**RE: CONTRACT NO.: 13/WSD/17
DESIGN, BUILD AND OPERATE FIRST STAGE OF TSEUNG KWAN O
DESALINATION PLANT
Submission of Detailed Design Plan for Chlorine and Carbon Dioxide Storage
of Desalination Plant**

Detailed Design Plan for Chlorine and Carbon Dioxide Storage of Desalination Plant

Contract No. 13/WSD/17 Design, Build and Operate First Stage of Tseung Kwan O Desalination Plant

Submission No.	TKOD1-RPT-A000-JGN0003-04		
Subject	Submission of Detailed Design Plan for Chlorine and Carbon Dioxide Storage of Desalination Plant	Date	9/07/2021
Version	04	Page	1 of 2

Appendix B - 5: Pressure Relief System of Inner and Outer Vessel of Insulated Tank and Carbon Dioxide Road Tanker

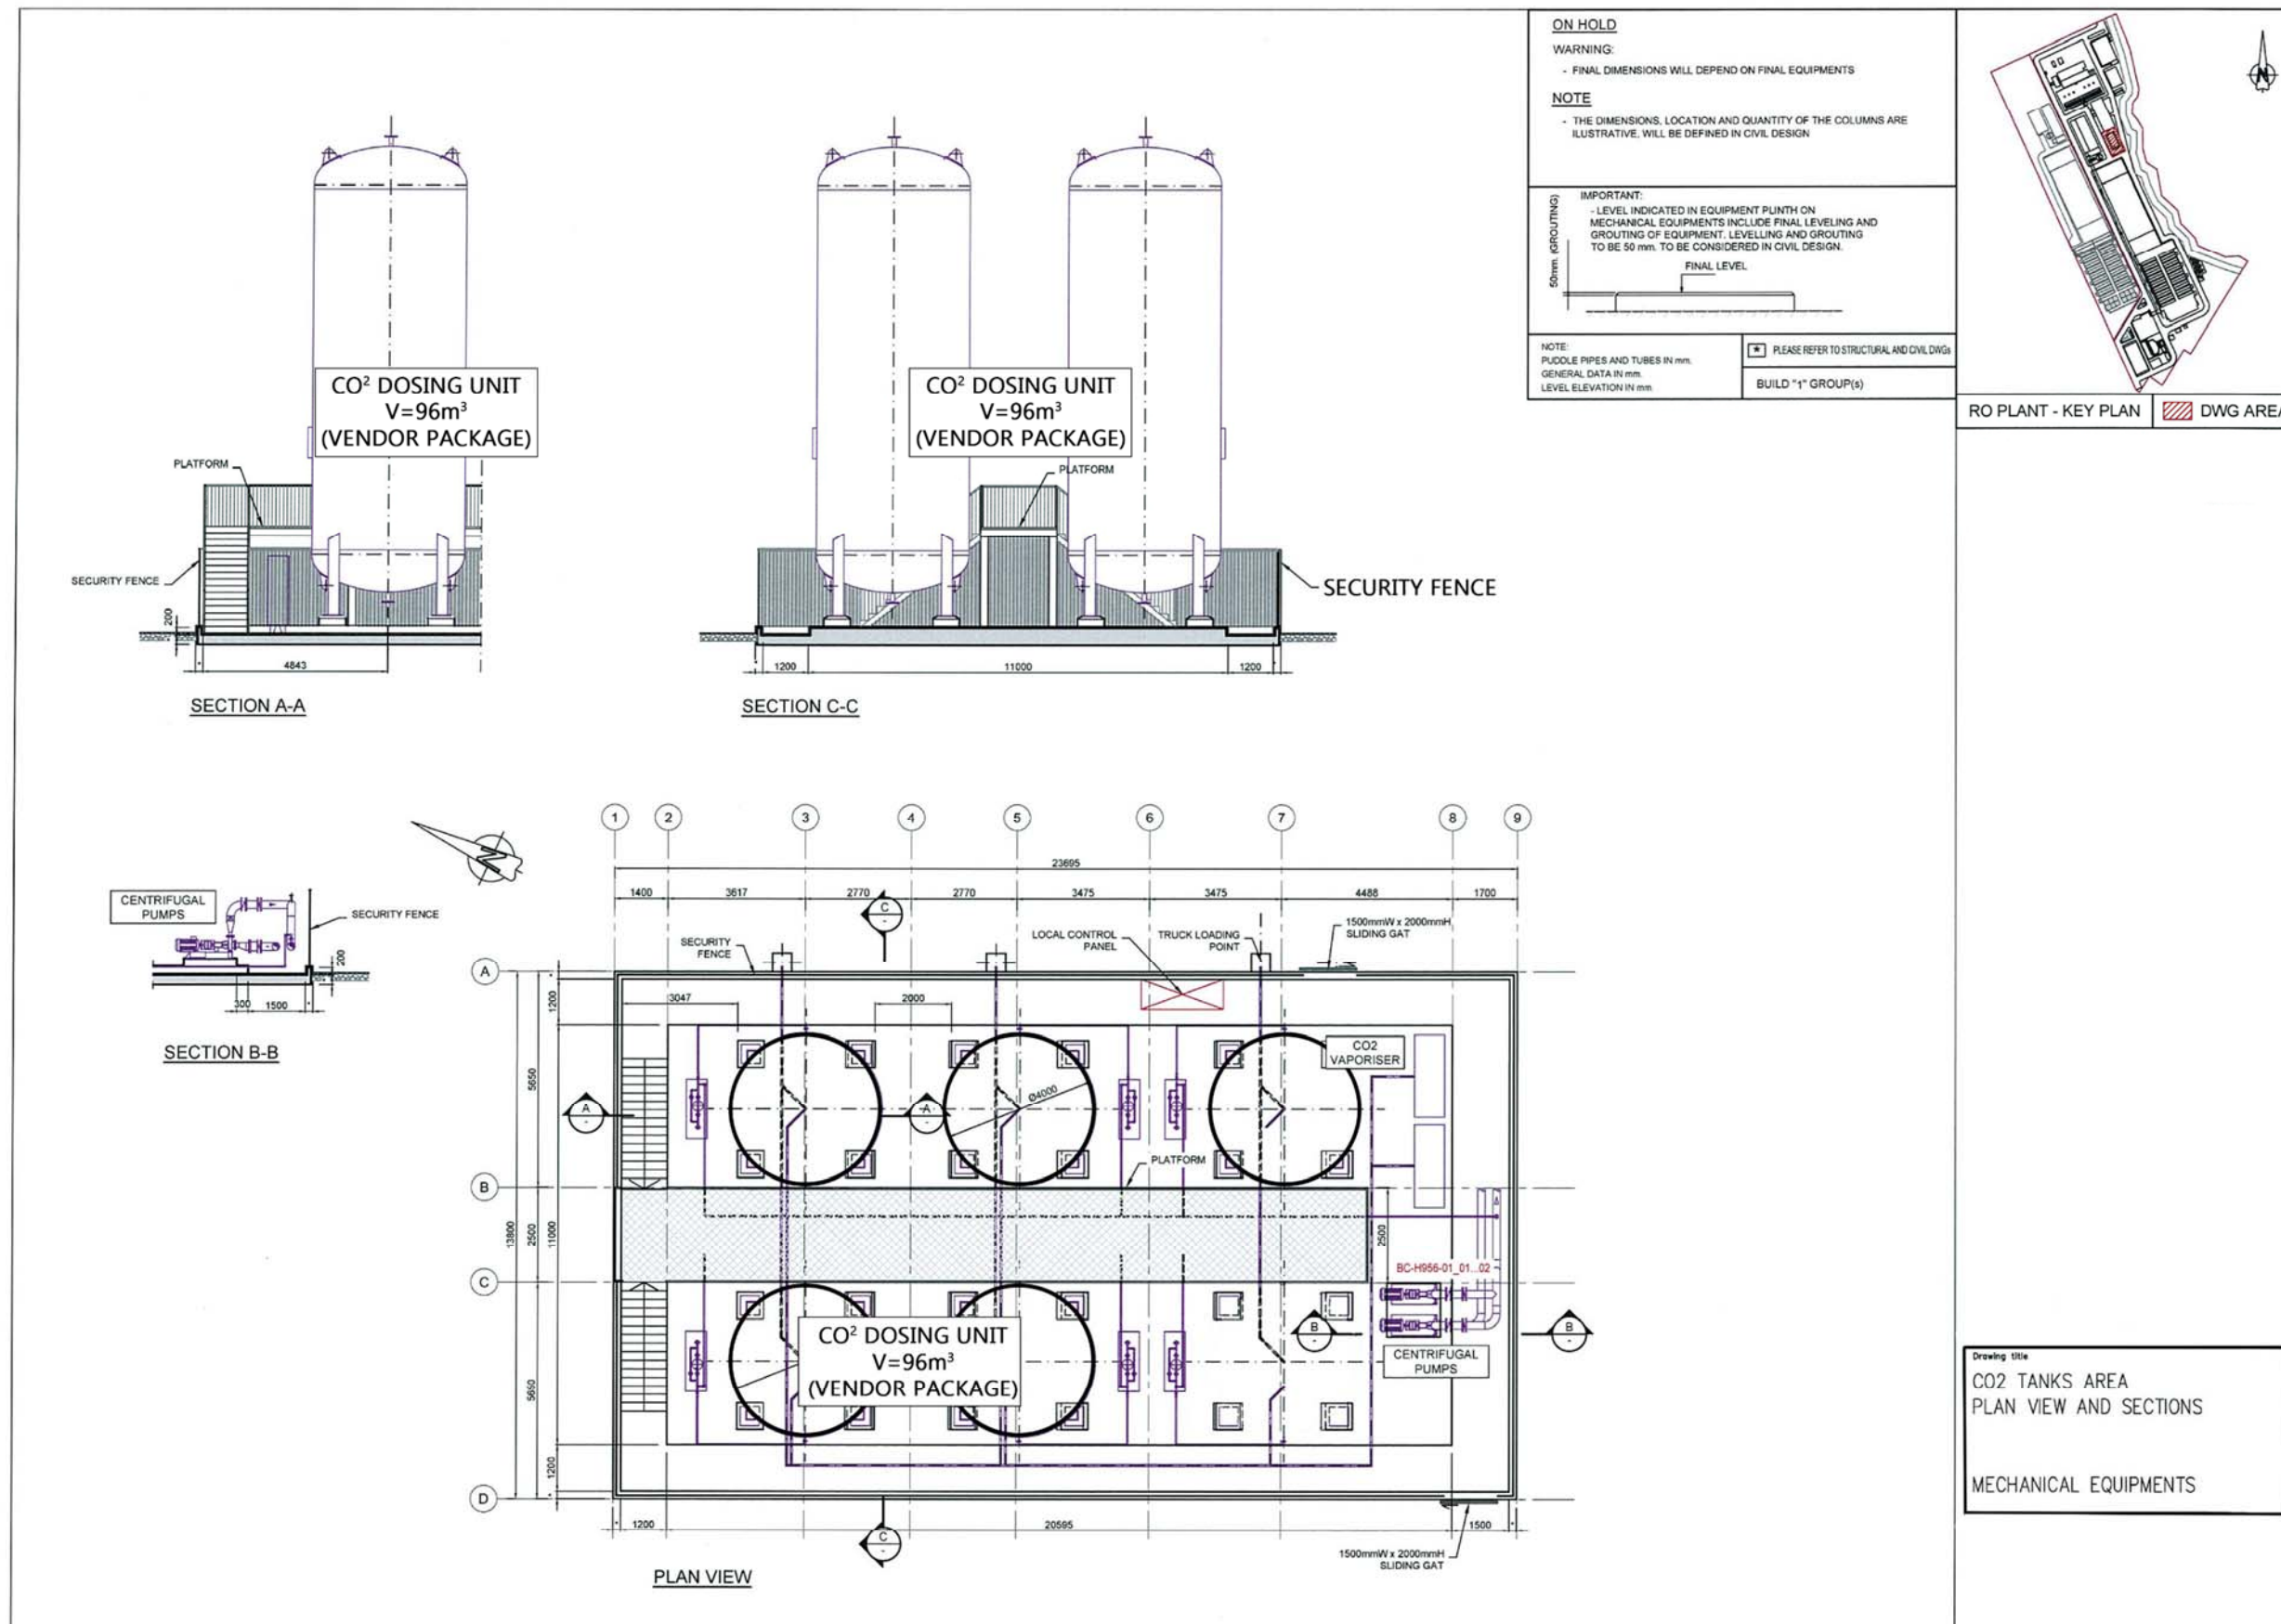
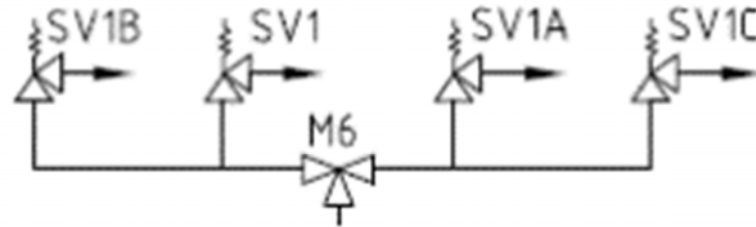
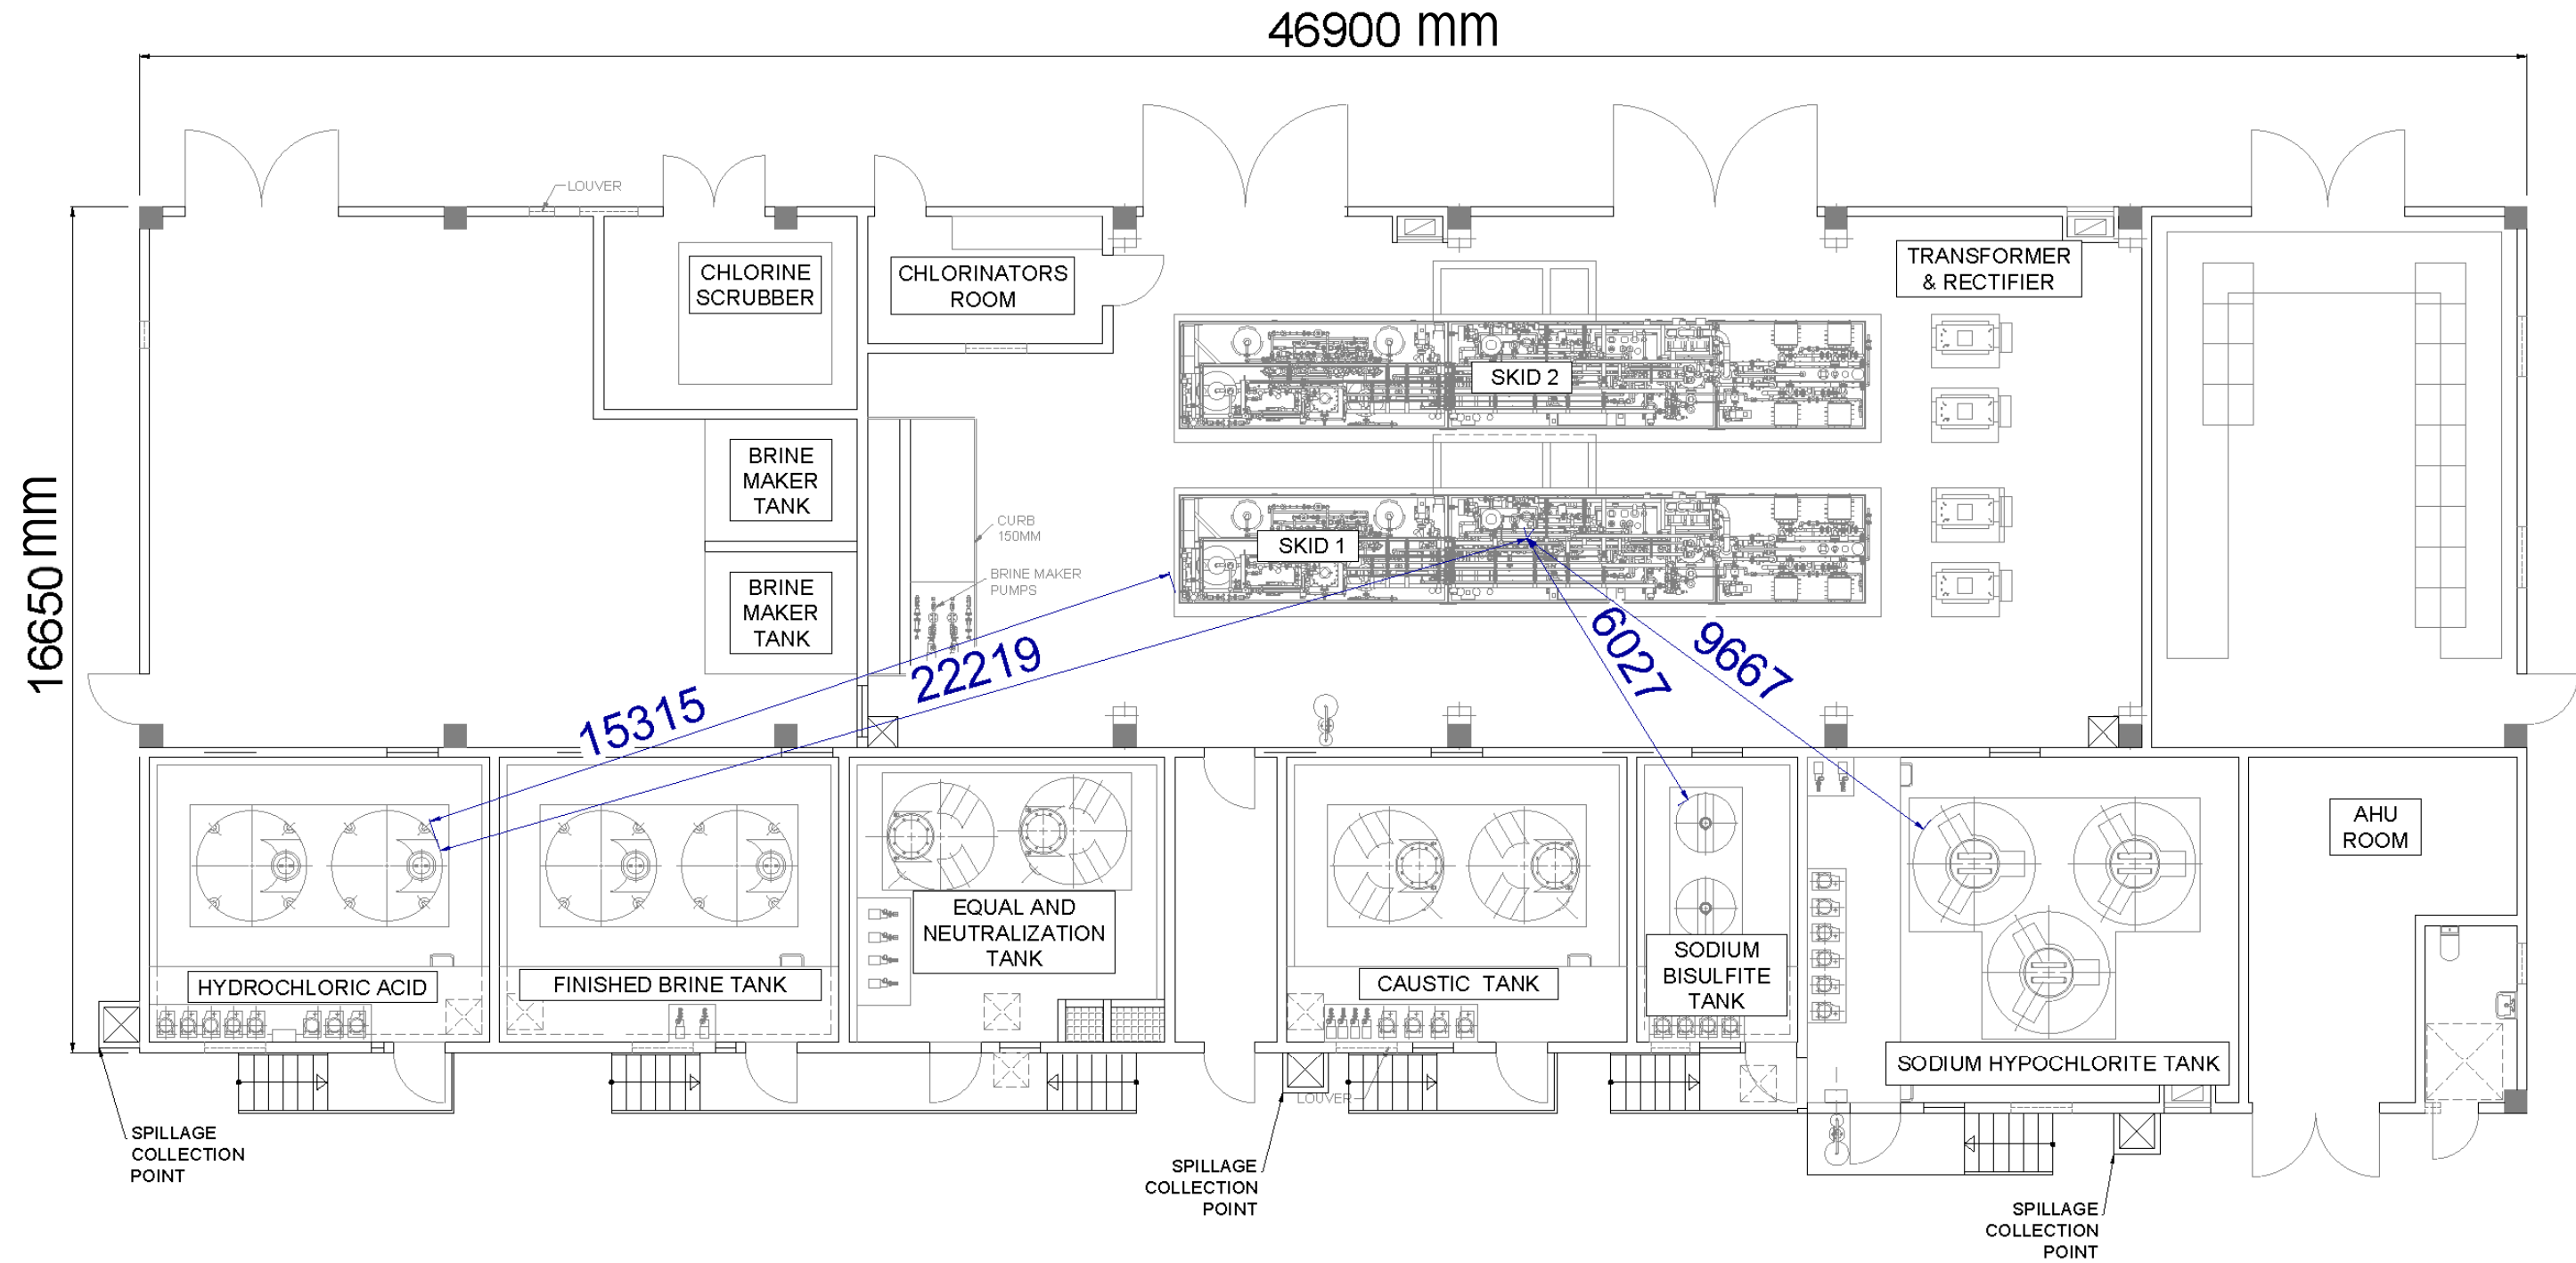
2. Appendix B Please explain how the design of the pressure relief valves system can avoid common mode failure.	Explanation has been added in Appendix B-5 of the revised plan. The P&IDs in Appendix B-2 have also been revised.

1. Appendix A, Item 2.5 Please clarify whether the explanations in Appendix B-5 are also applicable to carbon dioxide road tanker	Explanations in Appendix B-5 are also applicable to carbon dioxide road tanker. Text has been added in Item 2.5 of Appendix A and title of Appendix B-5 to clarify.

1. Two sets of relief valves, one duty and one standby. Such design allows annual calibration without interrupting the system.
2. There is a 3-way diverter valve to switch between duty and standby. Design of valve ensure opening at either side (ie. Either to left or right). There will not be accidental closing of both streams.
3. Each side consists of two relief valves in two settings, usually at 22 barg and 24 barg. The two stage design allows double protection. In case pressure rises too quickly that the first stage valve cannot release the pressure, there is the second stage relief valve for protection.
